LAKE NONA TOWN CENTER PHASE 2A

SUMMARY

Updated: March 23, 2017

Specific Parcel Master Plan (SPMP) approval to develop a ±1,241,000 square foot mixed use program; inclusive of 200 hotel rooms, a brewery, bowling alley, a medical fitness facility, and 3,870 parking spaces (surface, on-street, and garage).

**Figure 2—Growth Management Plan
City of Orlando Planned Bikeways 2030**

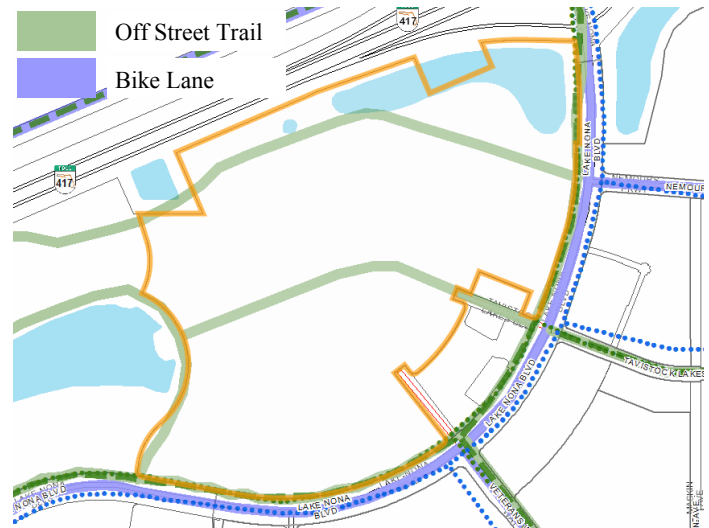
The proposed plan does not show adequate bicycle connections between the core of the Town Center and nearby uses. According to the Growth Management Plan Transportation Support and Recreation Policy Documents adopted by City Council (**Figure 2**), an "off-street dual use facility" should continue from Tavistock Lakes Blvd into the core of the Town Center. The conditions of this report require revisions to the plan to show a dual use facility extending from Tavistock Lakes Blvd through Lake Nona Blvd and into the core of the Town Center. Where this facility terminates, inside the core, substantial bike amenities, such as a bicycle station, should be provided. The minimum required width of a dual use facility is 10 feet, however the conditions of this report will allow for an 8 foot wide facility, with a 2 foot wide "door swing zone", in addition to the 8 foot minimum pedestrian clear zone.

In order to maintain connectivity through the Town Center to the loop road (as shown in the GMP), "sharrows," or some other form of shared-use markings, will be used in the Town Center core to indicate shared automobile/bicycle roadway. Additional trail connections may be required for future phases.

APPENDIX B: OFF-STREET TRAIL CONCEPT (SECTION VIEW)

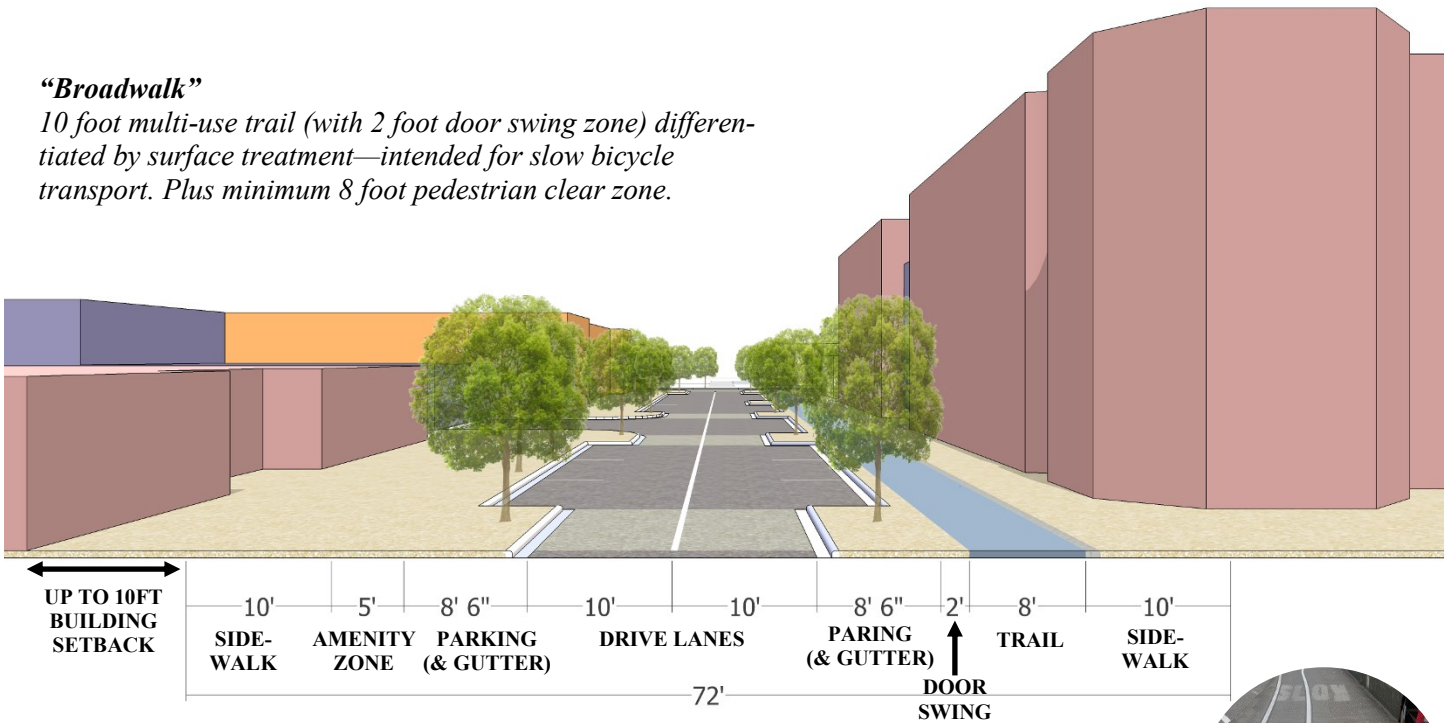
10 foot multi-use trail (with 2 foot door swing zone) differentiated by surface treatment—intended for slow bicycle transport. Plus minimum 8 foot pedestrian clear zone.
